Re: **Comments on Draft Environmental Impact Report for Estrella Substation and Paso Robles Area Reinforcement Project**

On behalf of California Unions for Reliable Energy (“CURE” or “Commenters”), we submit these comments on the Draft Environmental Impact Report (“DEIR”) prepared by the California Public Utilities Commission (“CPUC”) for the Estrella Substation and Paso Robles Area Reinforcement Project (“Project”). The Project is proposed by Horizon West Transmission (“HWT”) (formerly NextEra Energy Transmission West, LLC) and Pacific Gas & Electric Company (“PG&E”) (collectively referred to as “Applicants”). The Proposed Project would construct and operate a new 230 kilovolt (kV) /70 kV substation and a new 7-mile-long 70 kV

Figure 3: Cancer Risk Isopleth Map, Scenario 1 (Tier 4 Final Engines)⁸³

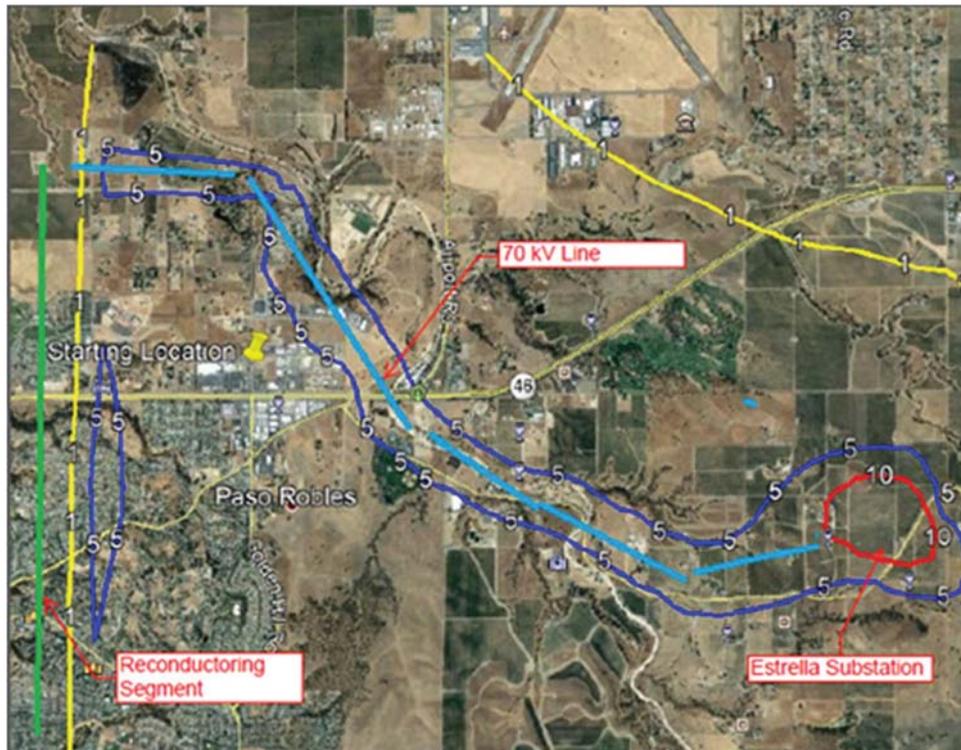
The cancer risk results for Scenario 1, which used the DEIR's DPM construction emissions based on 100% Tier 4 Final engines, are summarized in Figure 3.⁸² The cancer significance threshold is 10 cancer cases in one million exposed, or 10 in one million. The dark blue isopleth line corresponds to a cancer risk of 5 in one million, which is less than the cancer significance threshold.

Cancer risks only equal or exceed the significance threshold (red isopleth in lower right-hand corner of Figure 3 in the vicinity of the Estrella Substation). The PEA reports several residences within this isopleth. Table 1. Thus, if all Tier 4 Final engines are used for construction, cancer risks would only be significant in the vicinity of the Estrella Substation, requiring additional mitigation during construction of the Substation, such as mandating the use of biodiesel fuel in all construction equipment. However, the DEIR does not require all Tier 4 final engines or the use of biodiesel fuel.

Figure 4: Cancer Risk Isopleth Map, Scenario 2 (Tier 2 Engines)⁸⁴

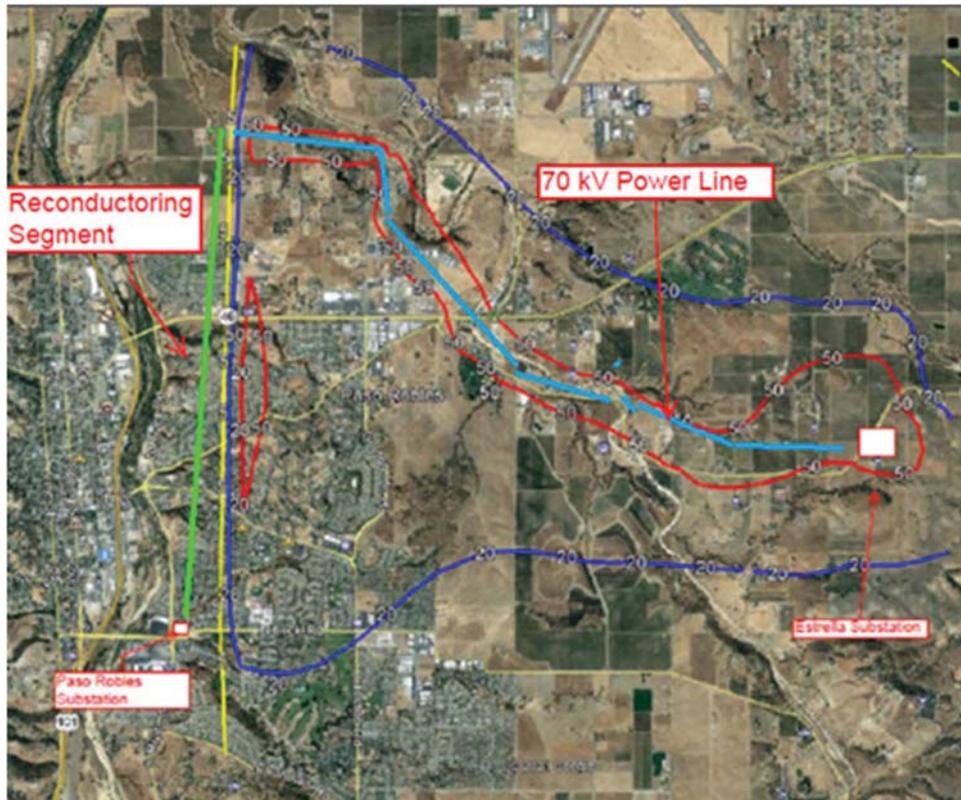
The cancer risk results for Scenario 2, which is based on the use of all Tier 2 construction equipment, as allowed by the DEIR (which only encourages an increase in Tier 3 engines, but does not require them), is summarized in Figure 4. The red isopleth line corresponds to a cancer risk of 50 in one million. The dark blue isopleth line corresponds to a cancer risk of 10 in one million. All sensitive receptors within these isopleths will experience significant cancer risks during construction.

The PEA identifies numerous sensitive receptors in the areas encompassed by these isopleths. Notably, it identifies residences “too numerous to pinpoint” within 50 feet of the reconductoring segment as well as a church, daycare center, golf course, park, and swim and tennis club, among others. Table 1.

Figure 5: Cancer Risk Isopleths for Scenario 2, Showing Homes East of the Reconductoring Segment⁸⁶

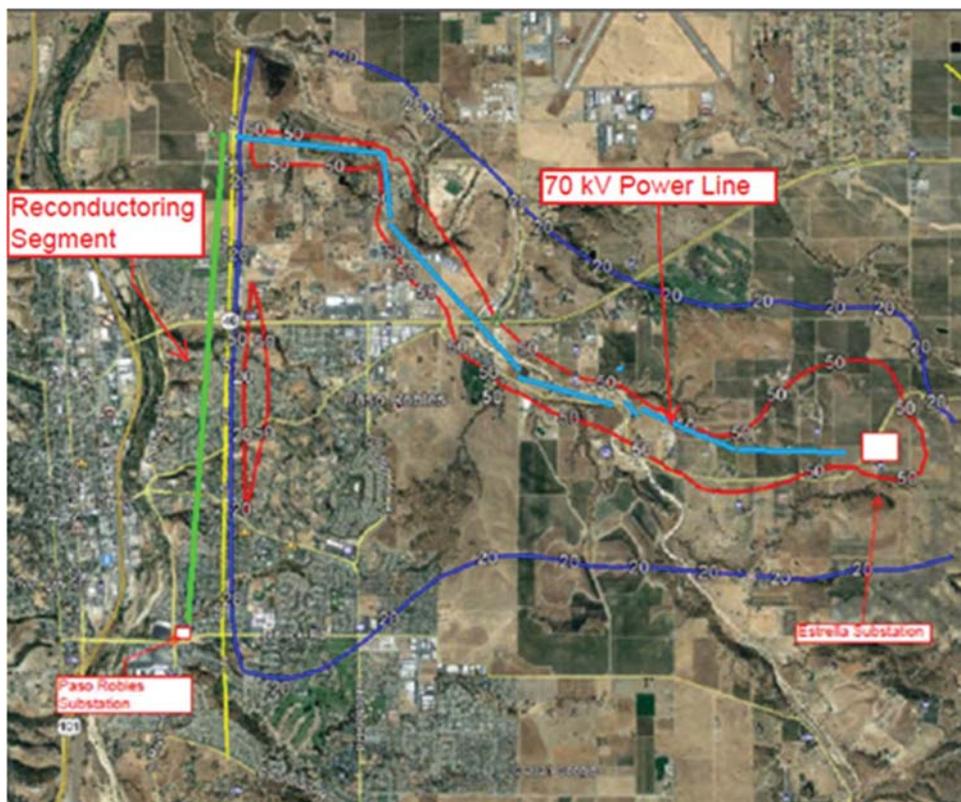
Figure 5 shows a close-up view of the area east of the reconductoring segment. This figure shows hundreds of homes within the 20 to 50 cancer cases per million isopleths. These are highly significant cancer risks, two to five times higher than the significance threshold of 10 in one million, requiring mitigation. These risks can be

mitigated by requiring the use of all Tier 4 construction equipment and diesel particulate traps (soot filters)⁸⁵.

Figure 6: Acute Health Isopleths for Scenario 1⁹⁰

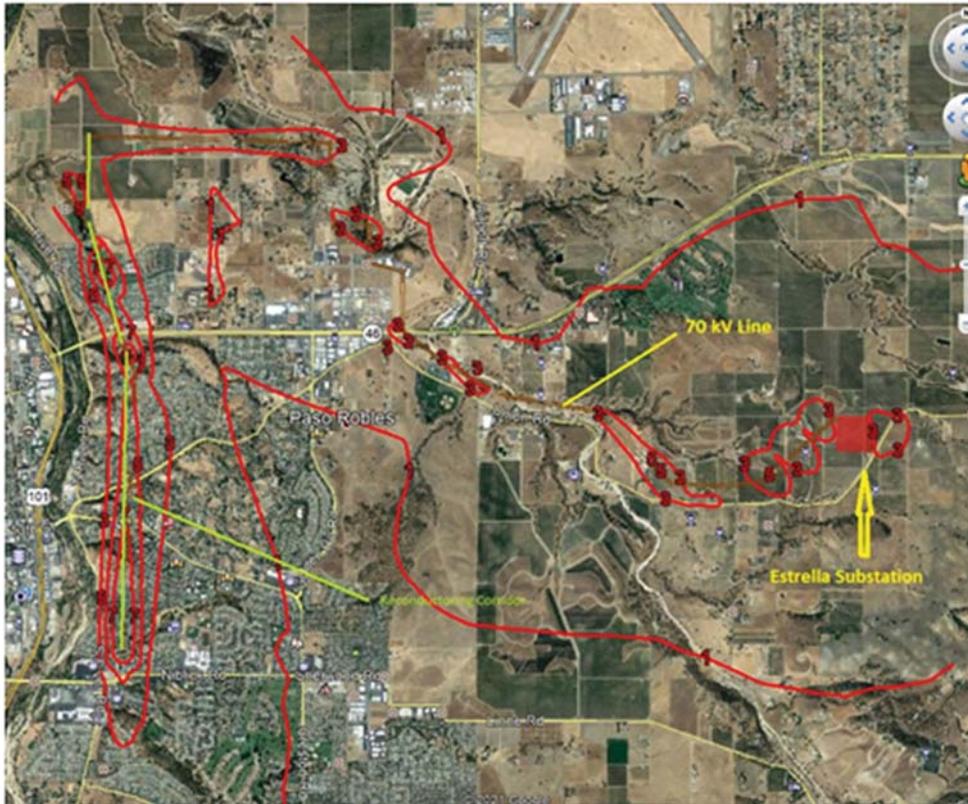
Figures 6 and 7 show isopleths for acute health impacts of DPM emissions during construction for Scenario 1, which assumed all Tier 4 final construction equipment and Scenario 2, which assumed all Tier 2 construction equipment. An acute hazard index greater than 1 is significant. Thus, the isopleths that show acute hazard indices greater than 1, such as those around the Estrella Substation, the 70 kV line, and the reconductoring segment are highly significant in both scenarios. Sensitive receptors in these locations will experience significant respiratory impacts.

Figure 9: Ambient Construction NOx Concentrations, Scenario 2⁹⁵

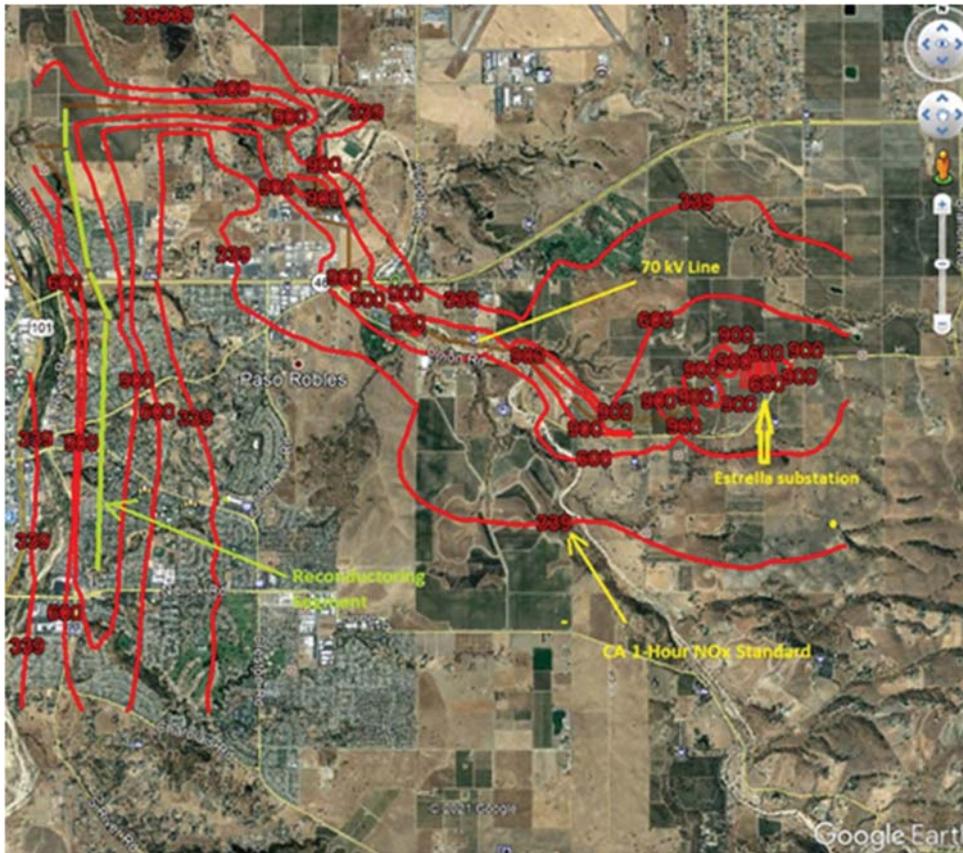
The result of modeling construction NOx emissions assuming the use of all Tier 3 construction equipment are shown in Figure 9. This figure shows that the California 1-hour NOx ambient air quality standard would be reach 900 ug/m³, nearly a factor 3 higher than the California 1-hour ambient air quality standard, in the vicinity of all Project components in locations with numerous sensitive receptors. This is both a significant air quality impact (violation of a state ambient air quality standard) and a significant health impact, as the state NOx standard was set to protect public health.

**Figure 16: Segments of Transmission Line (in blue)
Proposed for Undergrounding (in pink)**

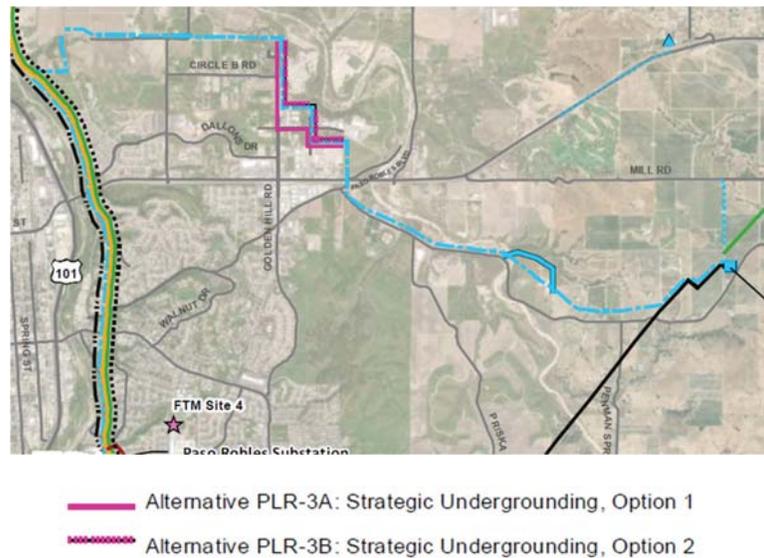
In spite of these comments, the DEIR failed to adopt undergrounding of any portion of the transmission line. While the DEIR developed two undergrounding alternatives, the DEIR failed to evaluate or adopt them, thus failing as an informational document under CEQA.

The DEIR included two alternatives to the aboveground transmission line, Alternative PLR-3A and PLR-3B to underground small portions of it, as shown in Figure 16. However, the DEIR failed to adopt either or explain why they were not adopted as they reduce otherwise highly significant aesthetic, public health, and biological impacts in the area as well as the risk of fire.

At a minimum, Alternative PLR-3, strategic undergrounding, should be adopted, as this segment of the transmission line passes through the Golden Hill Road area north of SR 46, which has the greatest potential for public health, aesthetic, biological, and other environmental impacts. Figure 16.
